PIC18F6310/6410/8310/8410 Rev. B3 Silicon Errata

The PIC18F6310/6410/8310/8410 Rev. B3 parts you have received conform functionally to the Device Data Sheet (DS39635C), except for the anomalies described below. Any Data Sheet Clarification issues related to the PIC18F6310/6410/8310/8410 will be reported in a separate Data Sheet errata. Please check the Microchip web site for any existing issues.

The following silicon errata apply only to PIC18F6310/6410/8310/8410 devices with these Device/Revision IDs:

FIGURE 1: SCK PULSE VARIATION USING TIMER2/2

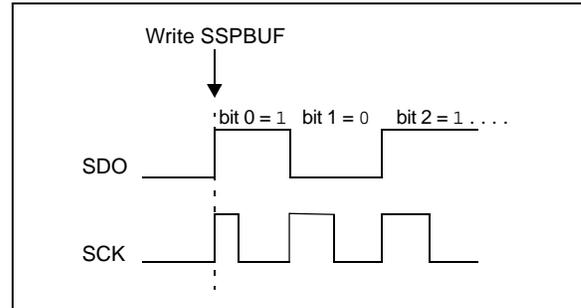
26. Module: MSSP (SPI Mode)

When the SPI is using Timer2/2 as the clock source, a shorter than expected SCK pulse may occur on the first bit of the transmitted/received data (Figure 1).

To avoid producing the short pulse, turn off Timer2 and clear the TMR2 register, load the SSPBUF with the data to transmit and then turn Timer2 back on. Refer to Example 4 for sample code.
